**DATE** October 21, 2020

**TO** John Rygh  
Save the South Fork  
Pete Dronkers  
Earthworks

**FROM** Betsy Semmens, RG

I have reviewed portions of the Draft Environmental Impact Statement (*Stibnite Gold Project, Draft Environmental Impact Statement*, United States Department of Agriculture, August 2020 (DEIS, 2020, referred to hereafter as “the DEIS”)) and the following groundwater modeling reports by Brown and Caldwell (BC) to evaluate potential impacts to groundwater from proposed mining activities at the Midas Gold Stibnite mine in Idaho:

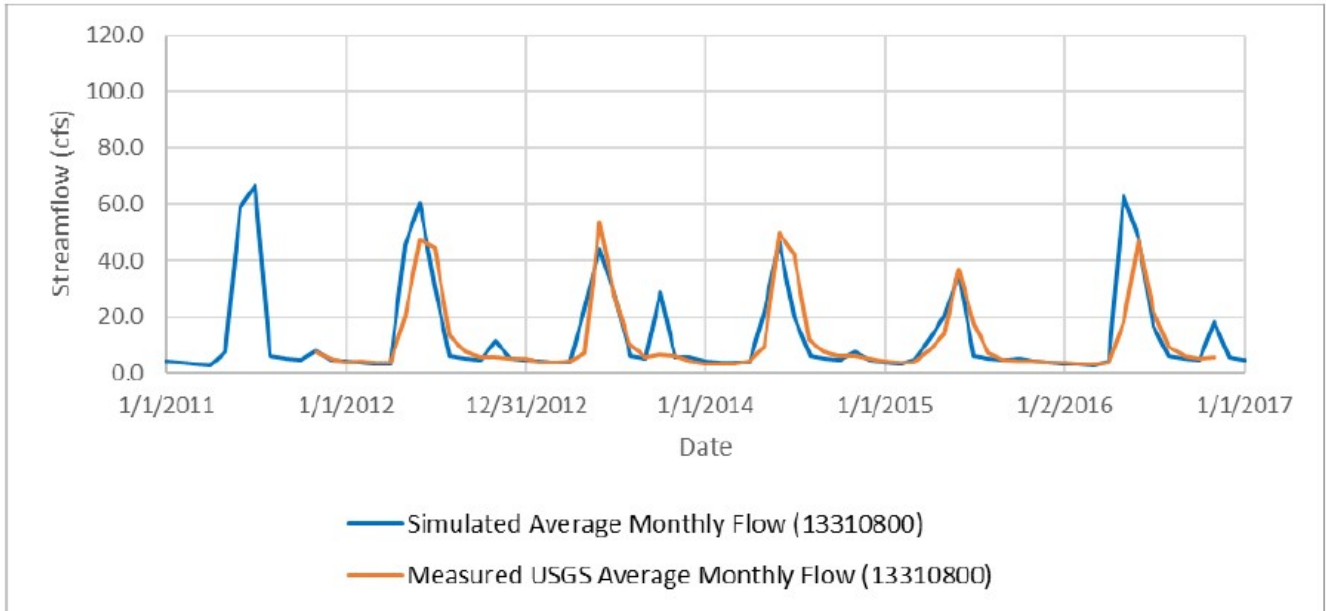
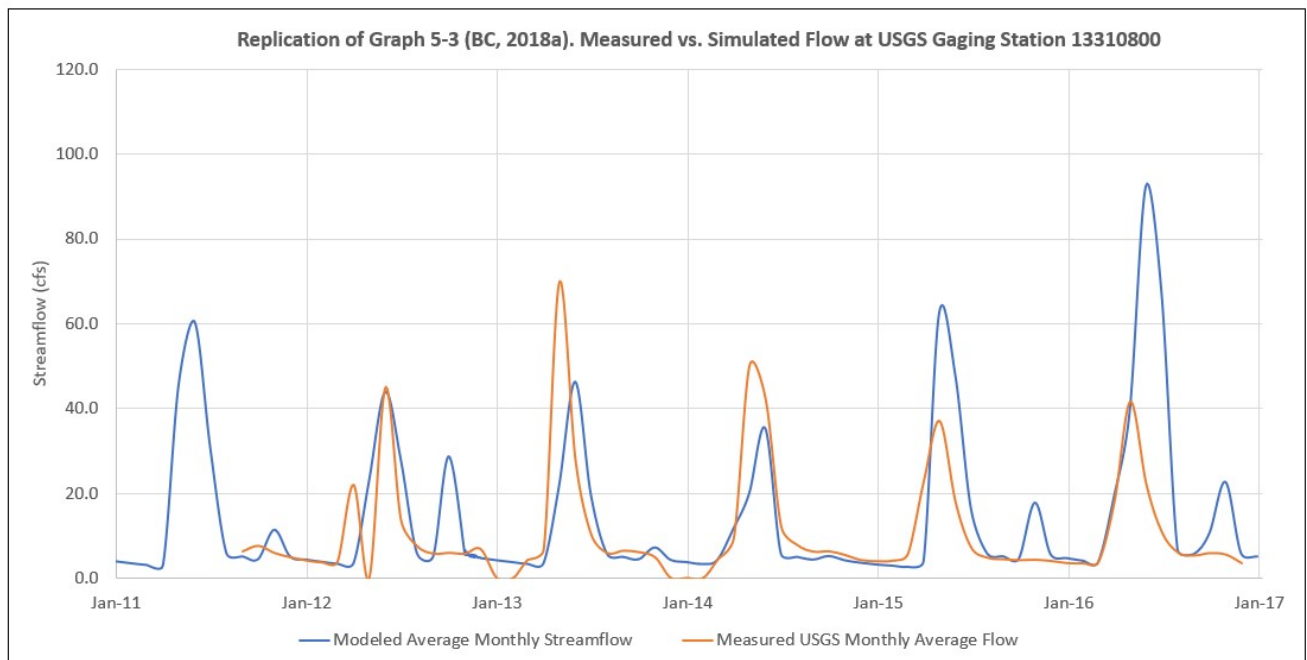
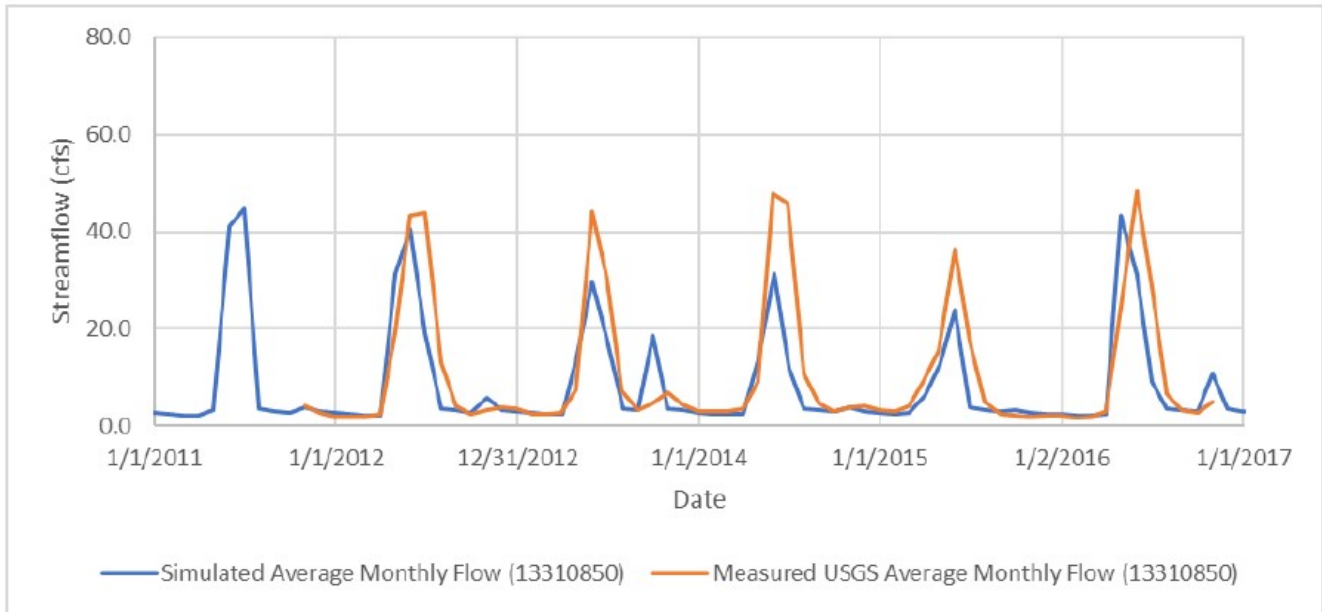
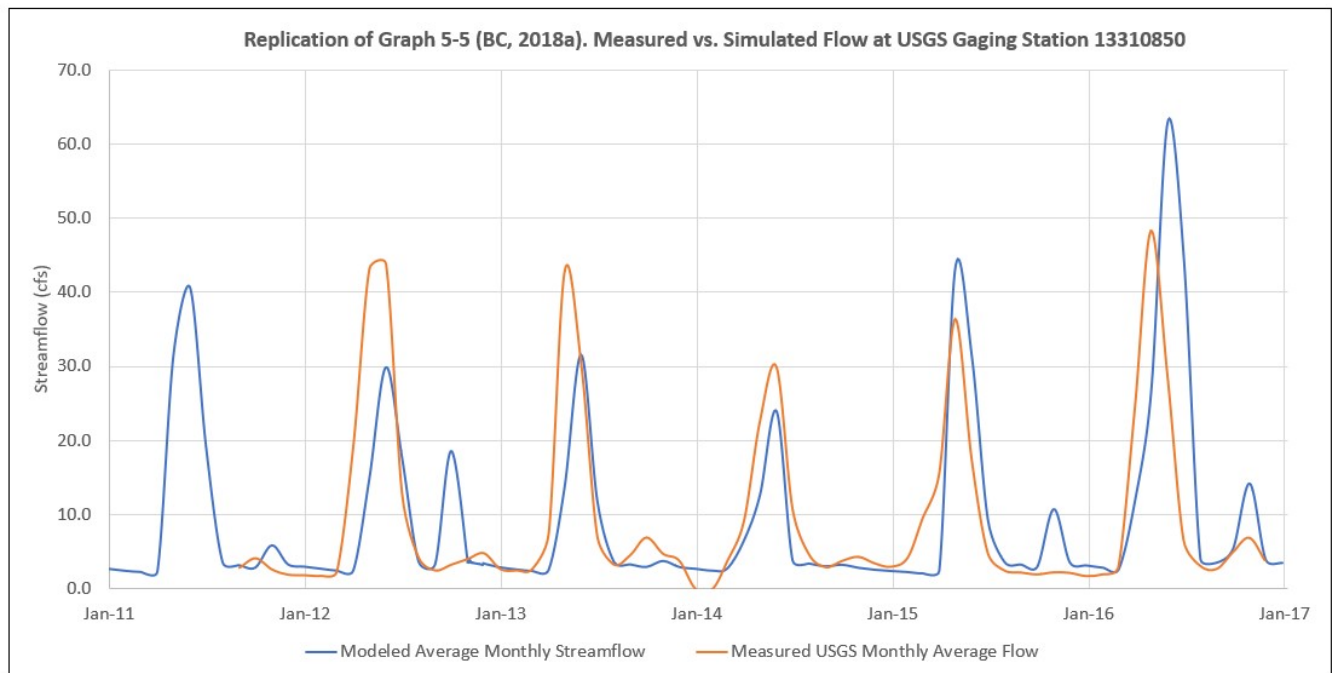
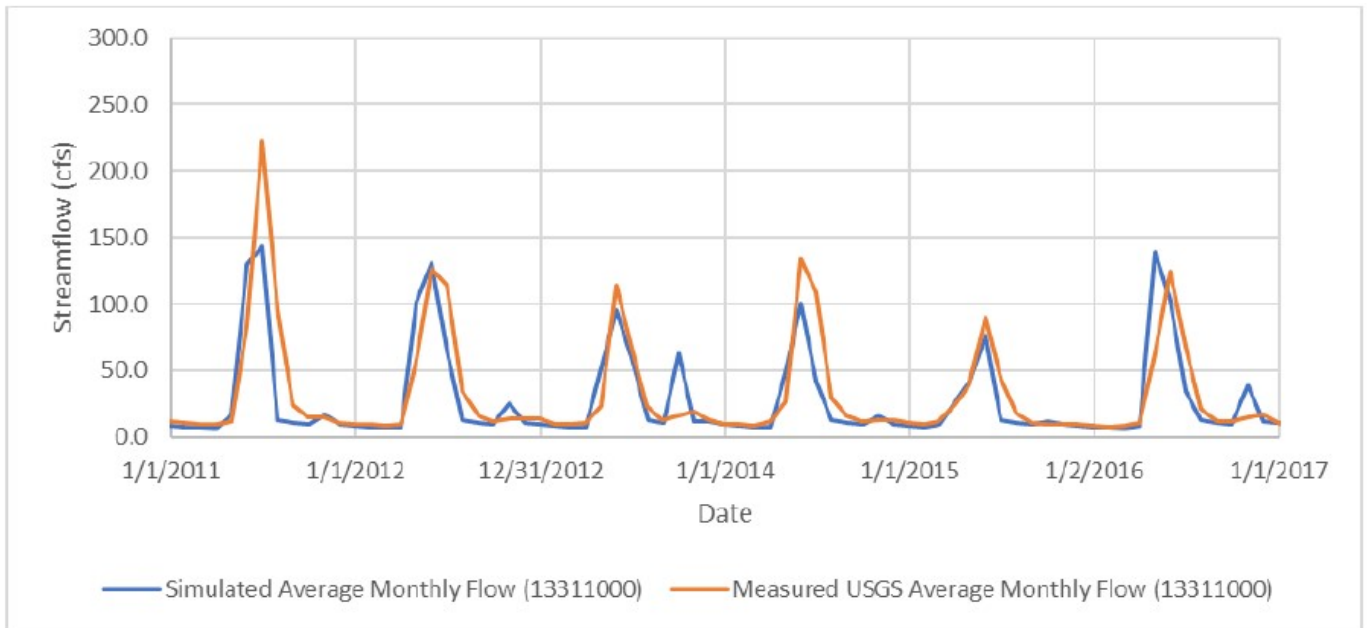
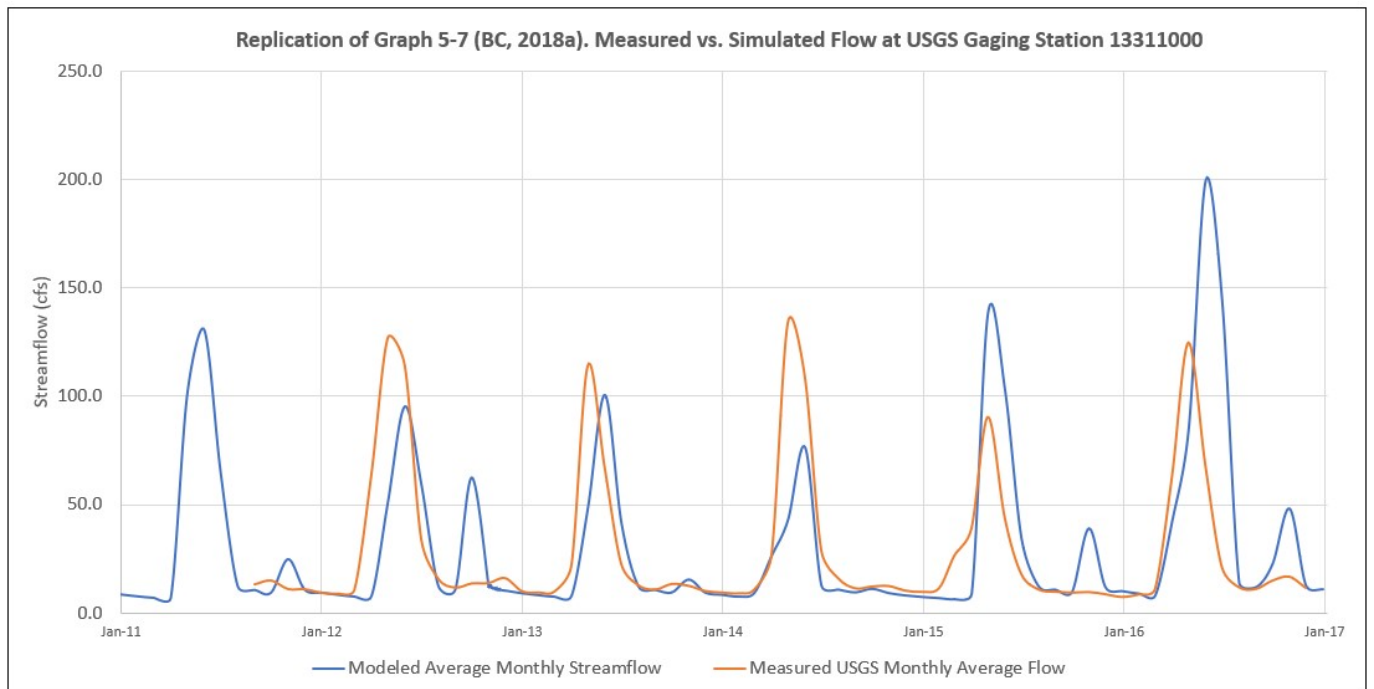
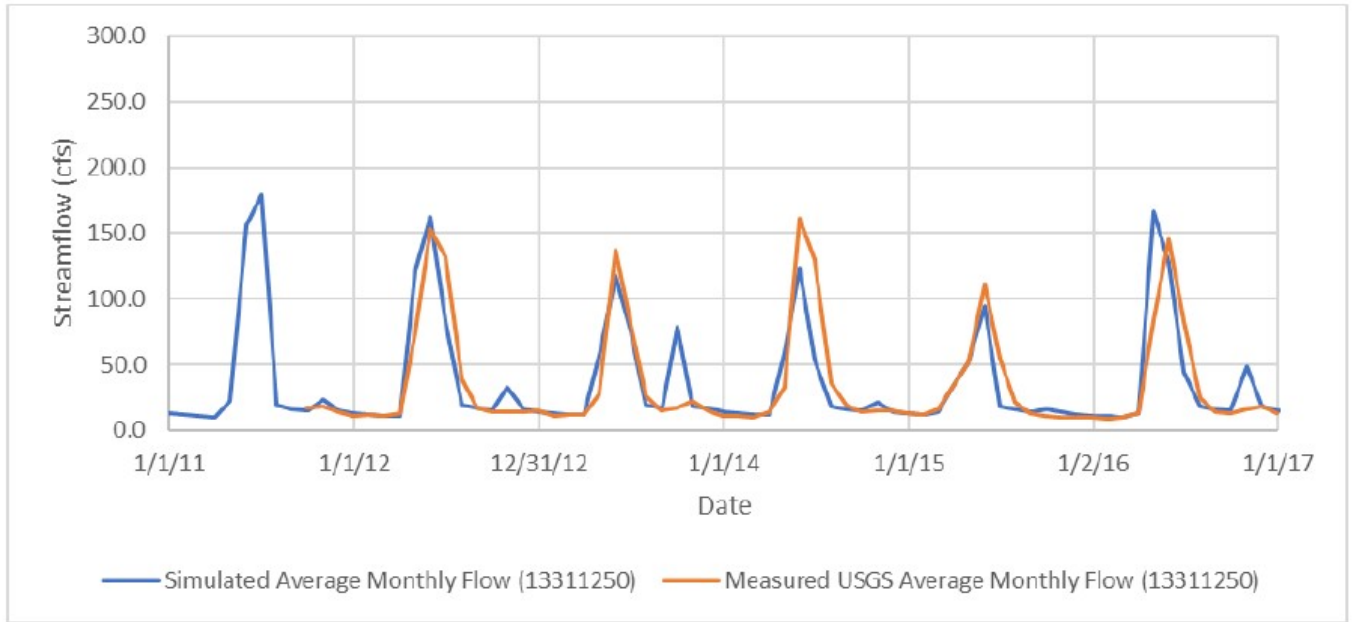
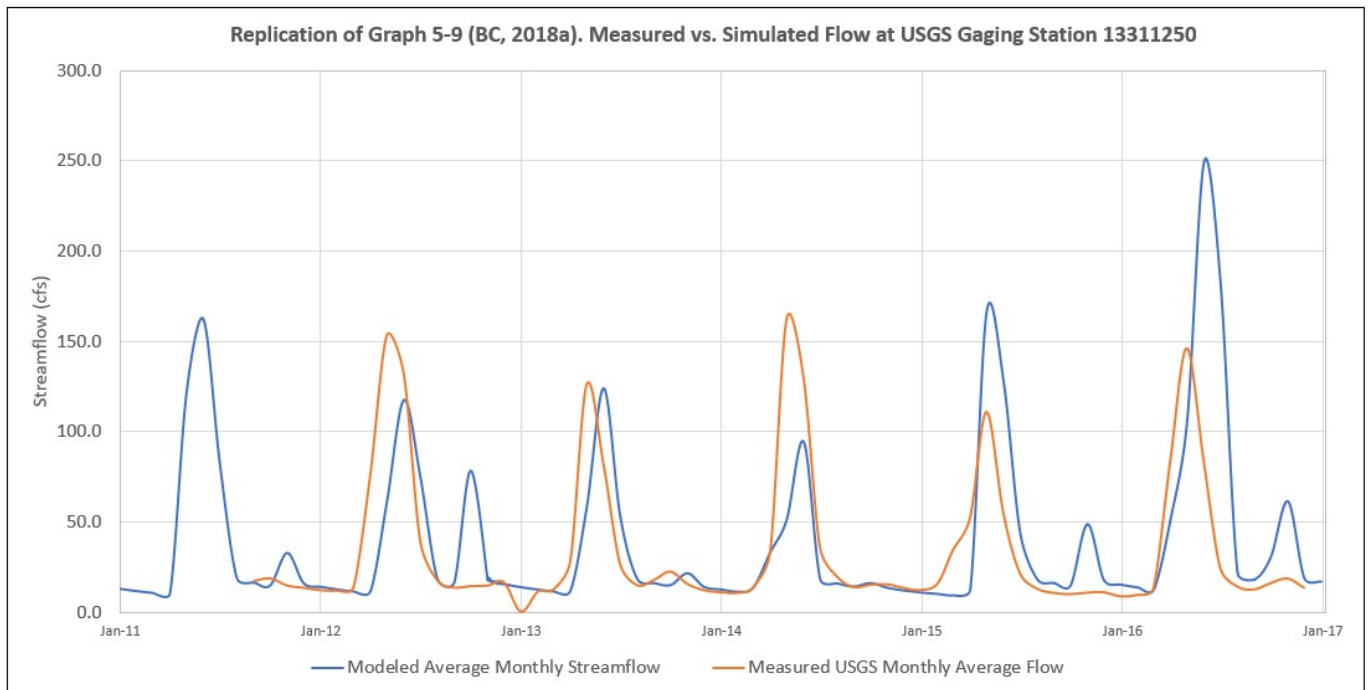
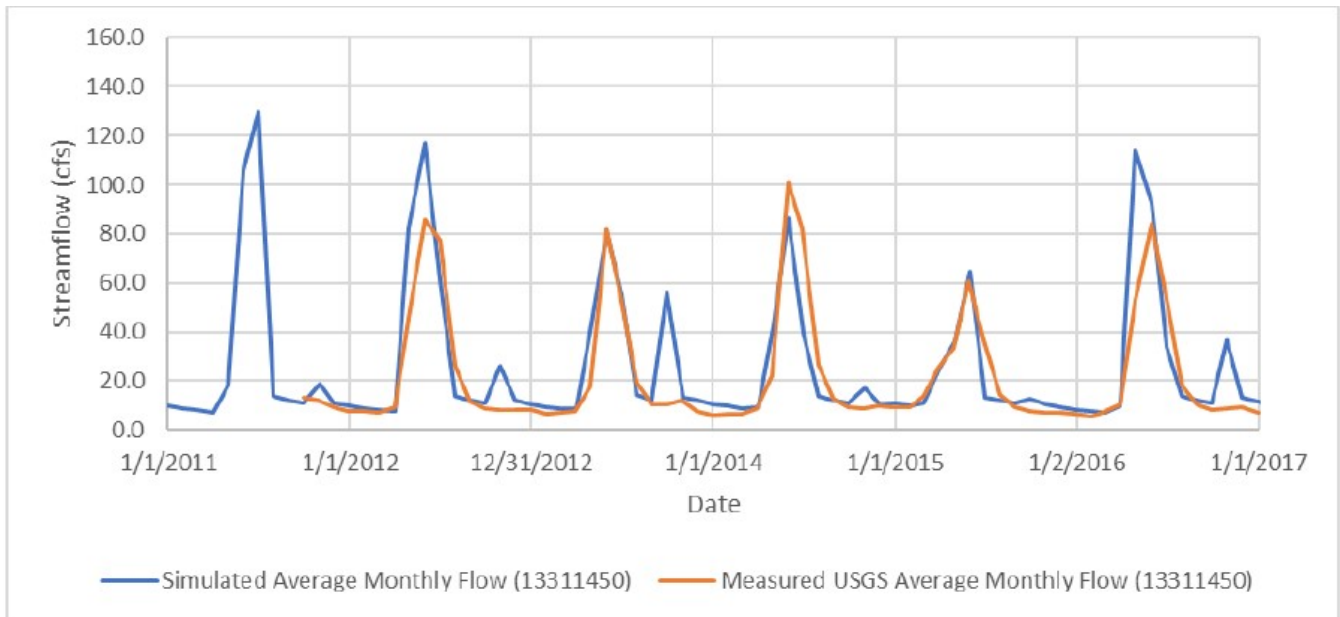
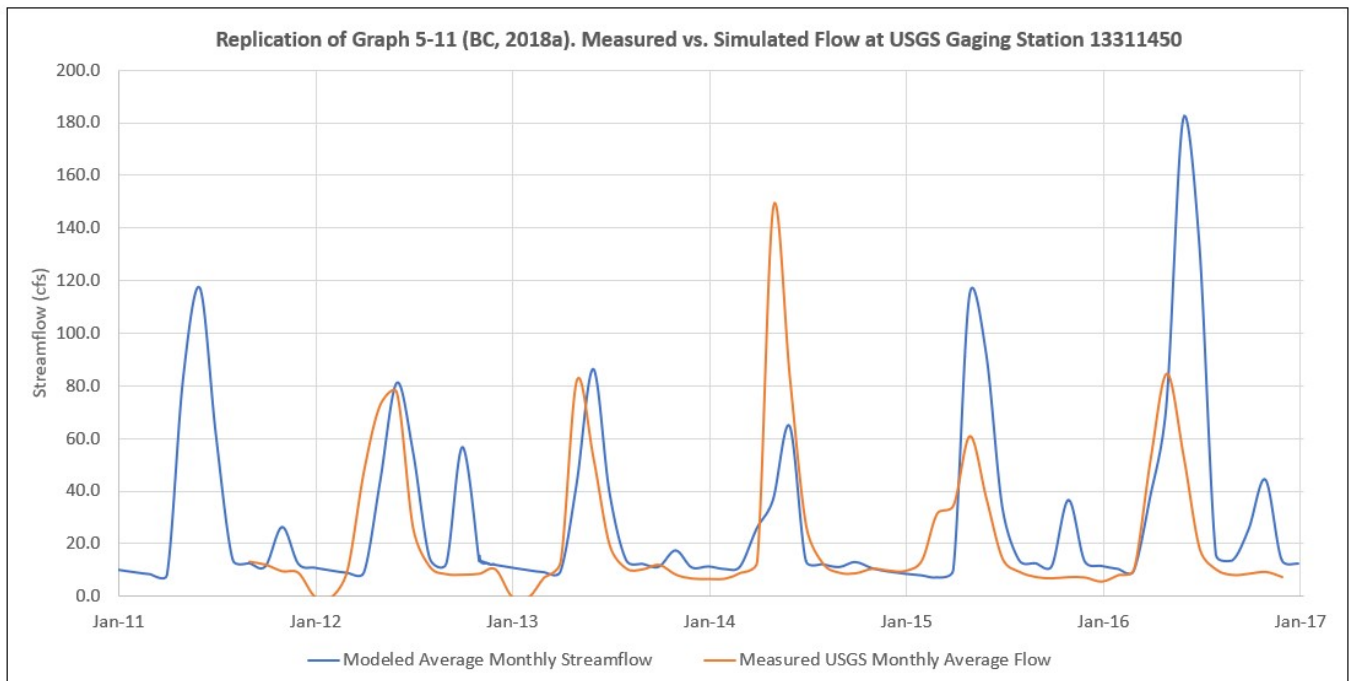
I downloaded the gage data for these USGS gaging stations and replicated the graphs shown in the existing conditions modeling report (BC, 2018a) to compare the model output from the provided model files (*Midas\_ExistingCond.gww*). The gage data were averaged monthly to be consistent with the data shown in Section 5 of the existing conditions modeling report (BC, 2018a). In general, the graphed output from the provided MODFLOW-NWT files for existing conditions does not match the output shown on graphs in the existing conditions modeling report (BC, 2018a), and in some places, the graphed measured gage data also do

not match. The difference between the modeled and measured streamflow is greater in the graphs that I produced from the model runs from the provided MODFLOW-NWT input files than what is shown in the modeling report (BC 2018a). In other words, the calibration to the measured streamflow is not as good when assessed from the replications of the graphs using the rerun model results.

Screen shots from the graphs in the existing conditions modeling report (BC, 2018a) are shown along with the new graphs created from rerunning the provided existing conditions model for all five gaging stations below. These side-by-side comparisons show that the match between measured and simulated streamflow is not as good as presented in the modeling report.

Figure 1. Most recent calibration residual using groundwater elevation data from Appendix C (SPF 2017)

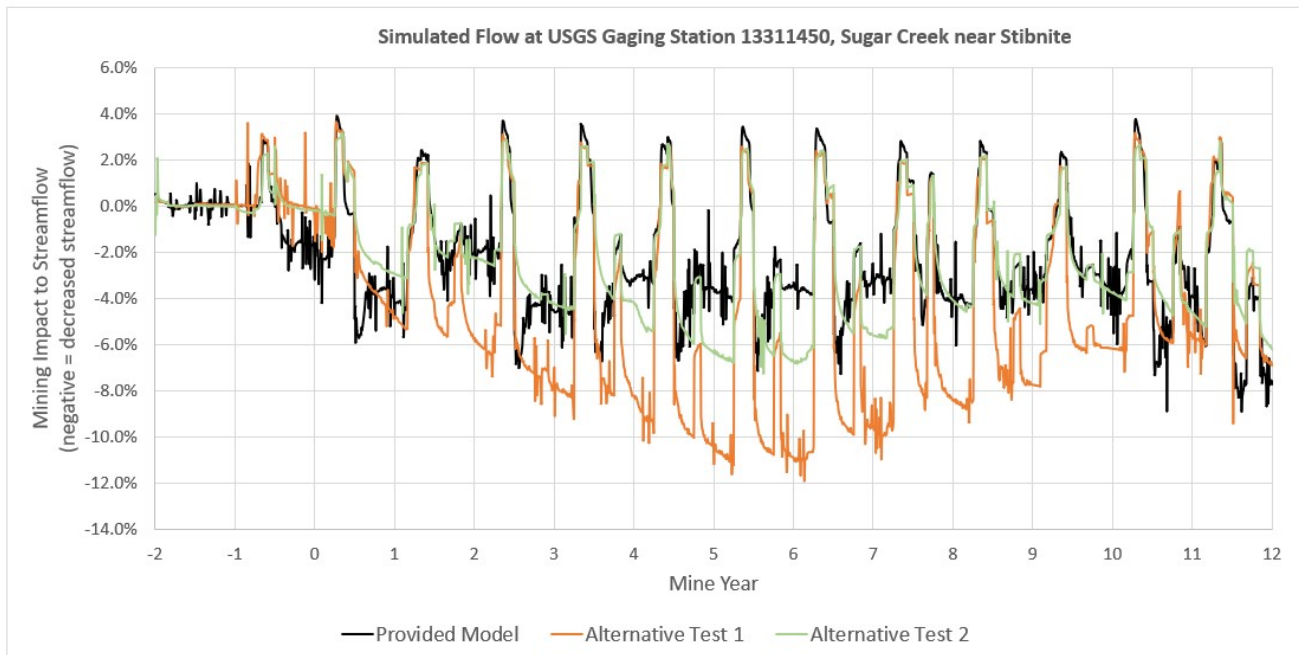
The resulting calibration scaled RMS errors for the entire model, model layer 1, and model layer 2 were: 6.0%, 3.3%, and 7.7%, respectively. These statistics are significantly worse than the statistics provided in Table 5-1 and suggest that the model is not as well calibrated as indicated, particularly in the shallow bedrock. The residuals for the most recent groundwater elevation data value from this set of calibration targets is shown in Figure 1 below. A negative residual indicates that the modeled water level is higher than the measured water level, while a positive residual indicates that the modeled water level is lower than the measured water level. Figure 1 shows significant bias that the model overestimates groundwater elevations (red markers), particularly near Yellow Pine pit and upgradient from Hangar Flats. In other words, the model's groundwater elevations are generally too high, likely meaning that the overall K values or recharge are incorrect.

Additionally, importing the calibration targets (monitor wells) using the well screen intervals from Appendix A (SPF 2017), several of the monitoring wells imported to model layers other than as indicated on Figures 5-4 and 5-5 of the modeling report (BC 2018a). Note that the model layering was not changed from that provided in the model files – the monitoring wells were simply imported to the provided model file using the coordinates and screen intervals provided in Appendix A (SPF 2017).

This shows that the model calibration presented in the modeling report (BC 2018a) is a) not as good as presented, and b) suspect because it is not able to be verified. Therefore, the validity of using this model for predictive purposes is uncertain.
